Groundwater & Wastewater Services
Septic Project File & Data Review Worksheet

GWS File #: 7477B WASPS App #: 2978

IMPROVEMENT PERMIT for a RESIDENTIAL ON-SITE WASTEWATER TREATMENT & DISPOSAL SYSTEM

Attached is a proposed design for an Accepted (25% reduction) Septic System with Pressure Manifold distribution for a 6 bedroom single family residence on Lot # 57 Abersham Subdivision, Mecklenburg County, North Carolina.

LAYOUT FOR 6 BEDROOM HOME — December 28, 2007

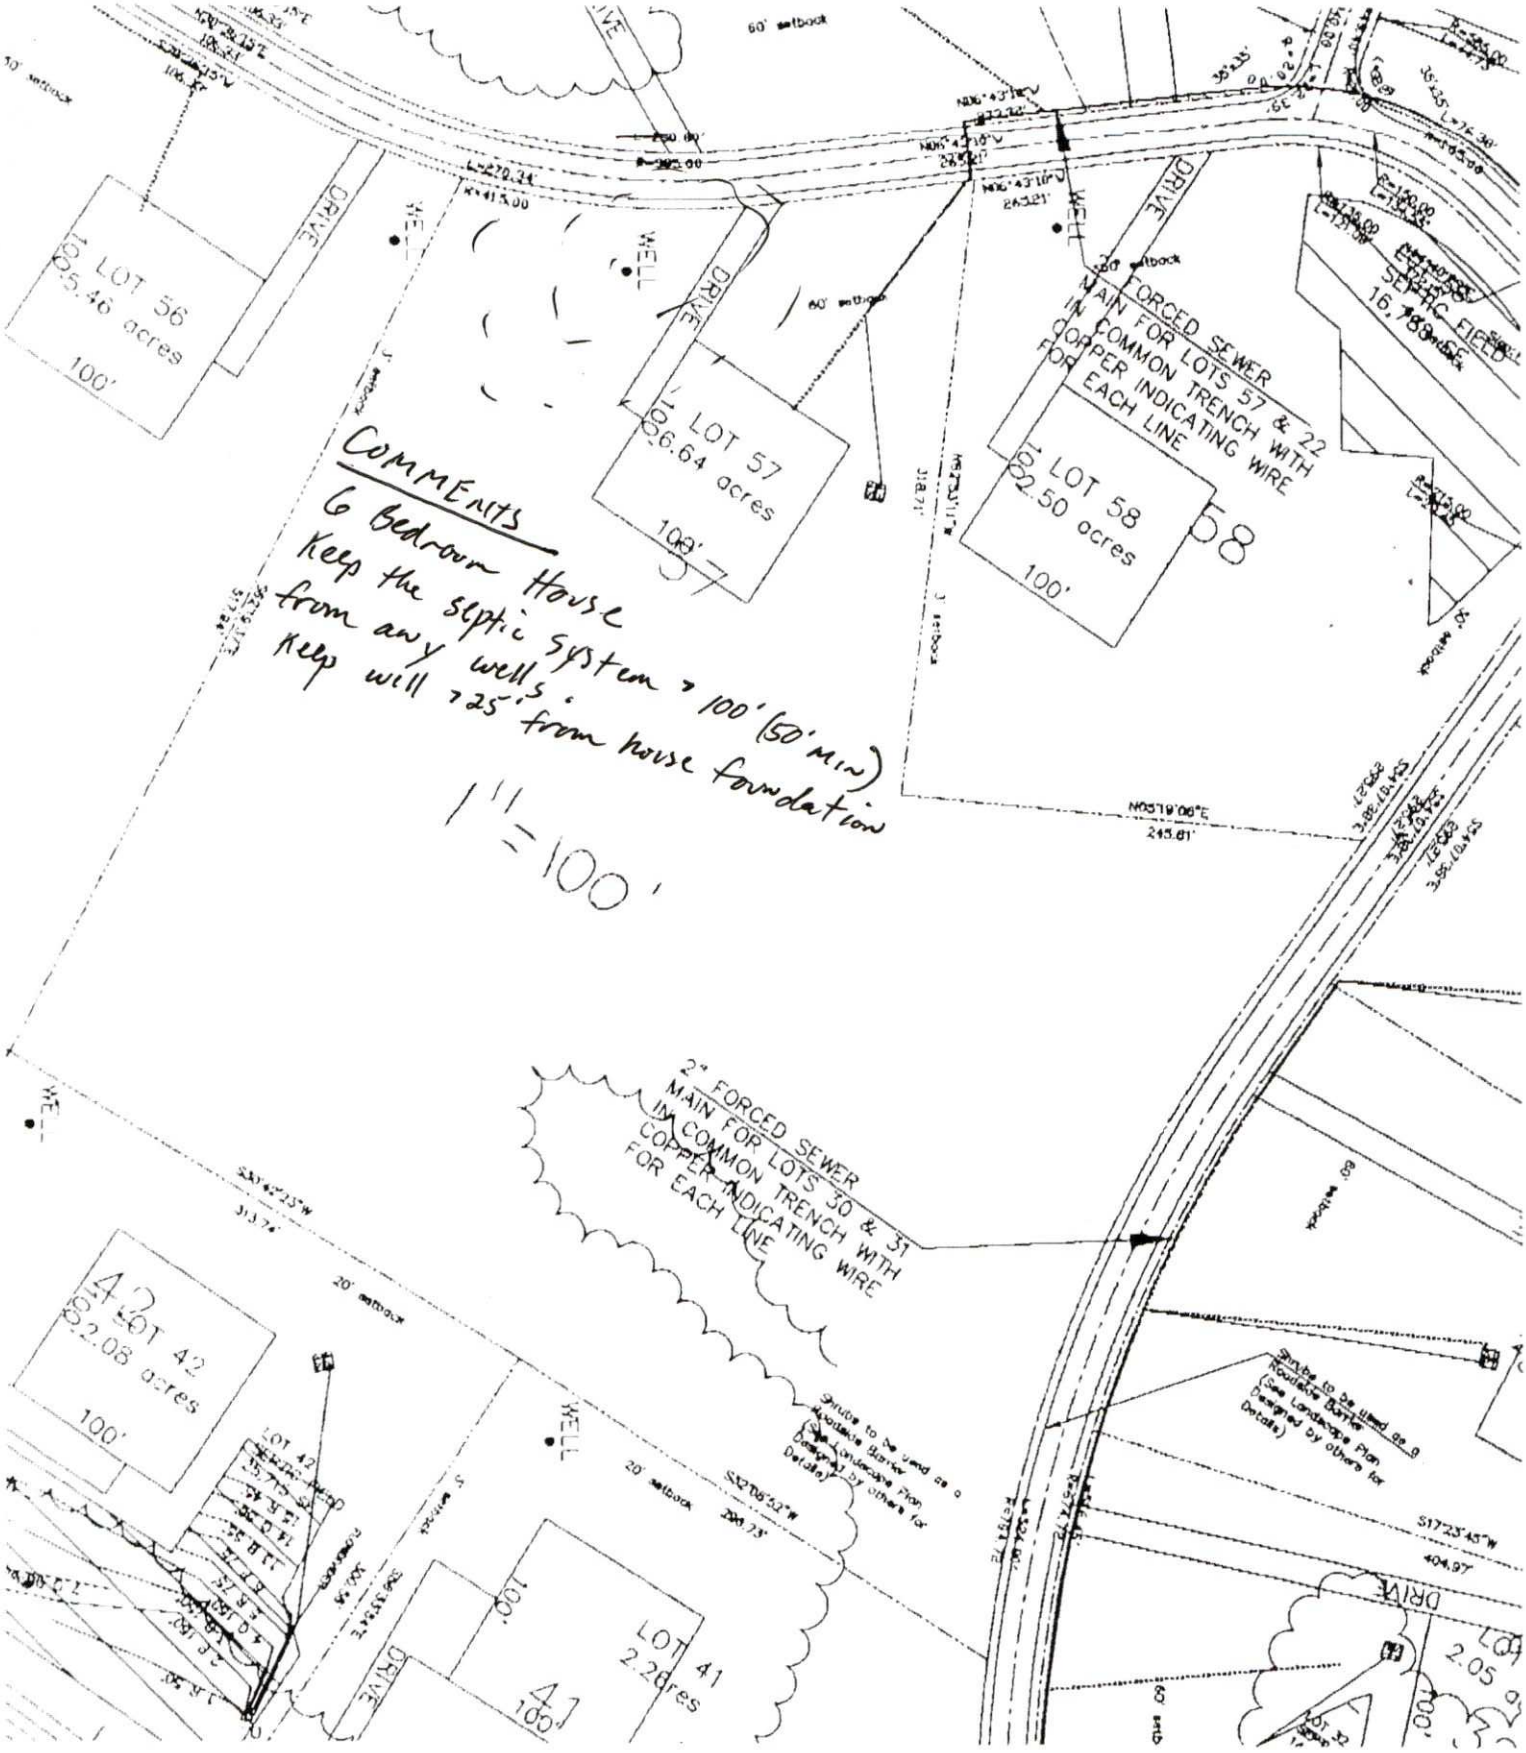
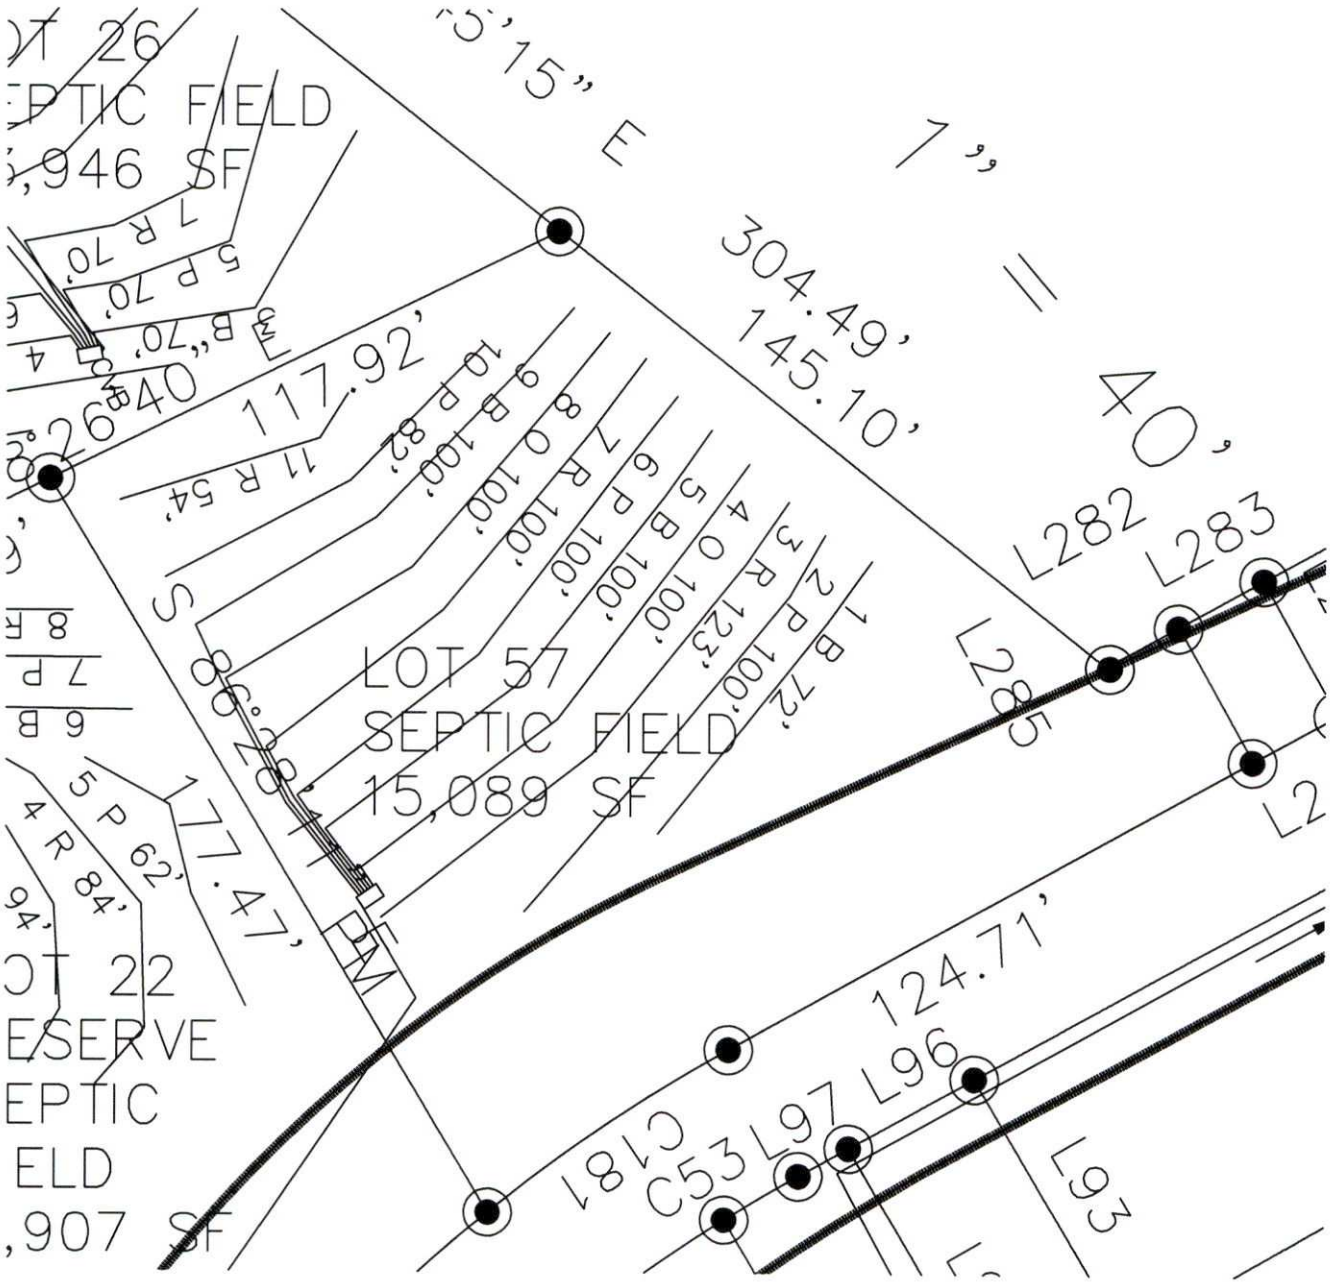
LTAR (0.275) DOES NOT MATCH DESIGN SPECS.

0.3

~~RER~~ REVISE & RESUBMIT.
